**Seattle
Design
Commission**

**APPROVED
MINUTES OF THE MEETING
21 February 2002**

21 Feb 2002 Project: **Woodland Park Zoo Discovery Village**

Phase: Schematic Design

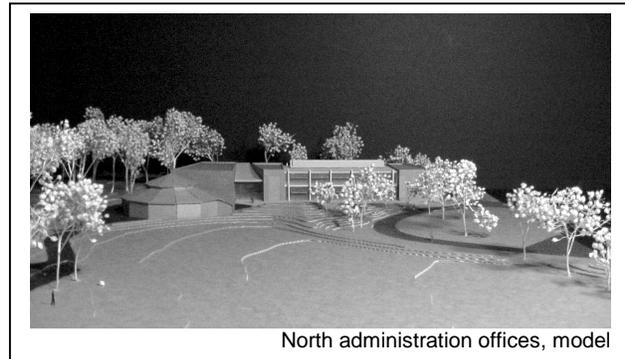
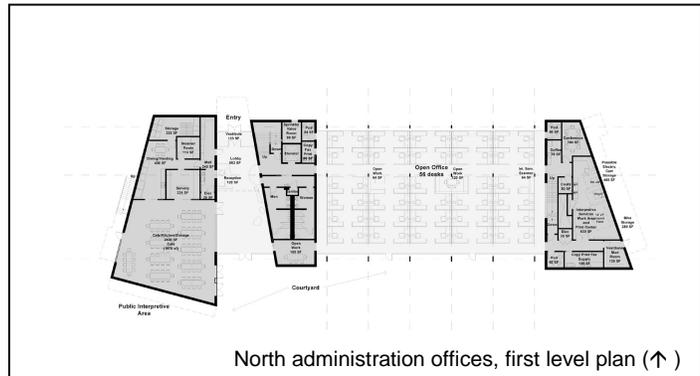
- **is concerned that the architectural character of the buildings within Discovery Village is not yet apparent, nor unified;**
- **feels that there is an opportunity to improve the design of the main Discovery Village plaza by architecturally linking the buildings, emphasizing their entrances, and simplifying the many forms and elements;**

- **appreciates the schematic design development of the north administration building, but encouraged greater resolution of its massing; and**
- **hopes that sustainability principles continue to guide the Discovery Village and north administration building designs, and supports the team's goal of aiming for the City's first LEED™ Silver and Platinum ratings.**

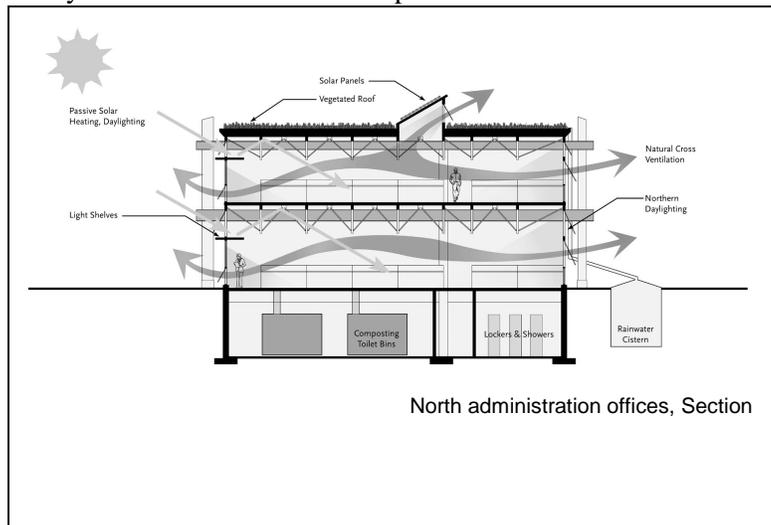
- Would like the design team to explain the architectural concept and design character for the buildings in the Discovery Village.
 - Proponents stated that the wild landscape zone penetrates the built area, and extends over the landscape of the buildings, through the incorporation of planters on the roof and sides of the buildings. The design intent is to capture the interdependence of humans and nature, also speaking to how humans live in nature. Further stated that there is an

- Appreciates the design team's response. Is excited that the landscape design has precedence over the buildings.
- Feels that the design team needs to refine the forms and simple volumes of these large buildings. Feels that the entrance condition at each of the buildings needs to be unified. Recognizes the sloping roofs mediating between the larger volumes and the smaller frame entrances. Would like to know if the design team has considered a simple, consistent arcade around the plaza, uniting the building facades at the plaza, recognizing the inconsistency around this edge. Believes that an arcade would mediate between the edge of the plaza and the heavy masonry buildings.

- Feels that the elevations of the conservation exhibit gallery and the Northwest biome conservatory are very different, architecturally. Feels that the entrances of these buildings should be very similar and clearly identifiable as components of the Discovery Village.

opportunity for buildings to be the key public interface from the plaza. The materials for these entries will be transparent, and the architectural character will be of a smaller scale, with crafted connections, creating an evocative, tactile area. There may also be a water tower reservoir for roof runoff, with sculptural elements to display this water conservation. Further stated that this may be an opportunity for kinetic operable components.

- Proponents stated that they have been considering these links throughout the design process, and hopes that there is an implied link between these buildings.

Ballard Automated Public Toilet

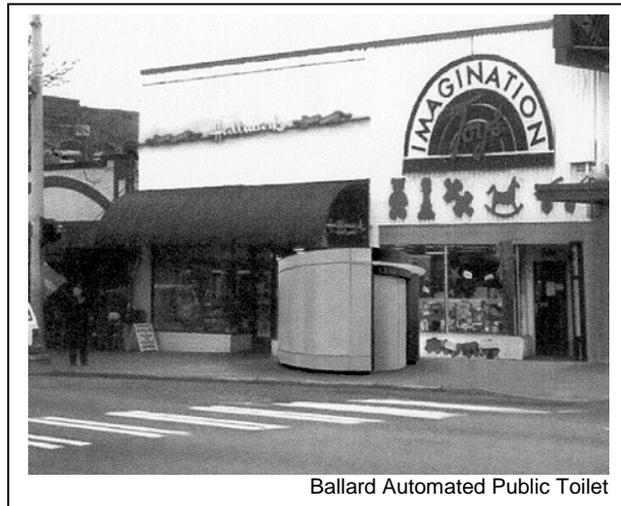
- Would like to know why the existing tree must be removed to site the Ballard APT.
 - Proponent stated that the APT could move a few feet to the west, but the tree would be in the path of people entering or exiting the APT.

- Would like to know if the APT could be moved to the west and rotated, to avoid the tree.
 - Proponent stated that the prevailing winds come from the west, and the APT is sited in consideration of these winds. The community would like the entry to this APT on the east.

- Would like to know if the bicycle rack and bench could be moved.
 - Proponent stated that these changes would affect the bus loading area. Further stated that the team explored many different locations for the APT at this site, but every alternate location would impede pedestrian access to buses.
